PRODUCT INFORMATION NOTIFICATION

PIN: PIN195002

Subject: Qualification of Kostat Tray in Cypress Thailand for 16-Lead SOIC Package

TITLE
 TRAY, SOIC16 10.30X7.50X2.65 MM (KOSTAT)

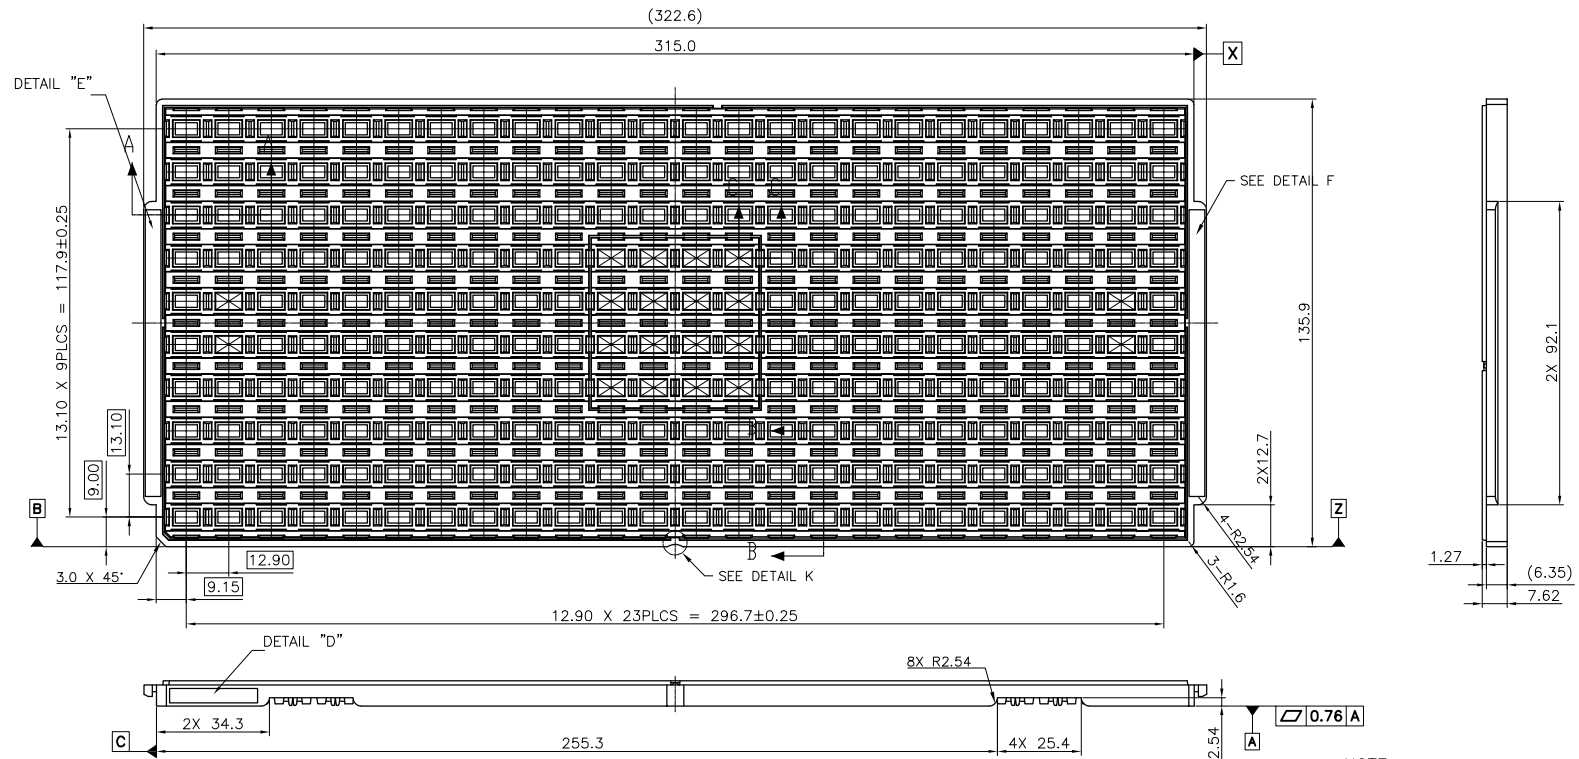
Cypress announces the qualification of Kostat KS-84052 tray to be used as in-process and shipping tray for 16-Lead SOIC package finished at Cypress Thailand (Cypress Semiconductor Thailand (Limited), 229 Moo 4 Chaeng Watthana Road, Pak Kret, Nonthaburi, 11120 Thailand). The Kostat tray is the same as the current tray with regards to critical dimensions that may affect application. It is also designed to be stackable with the current tray.
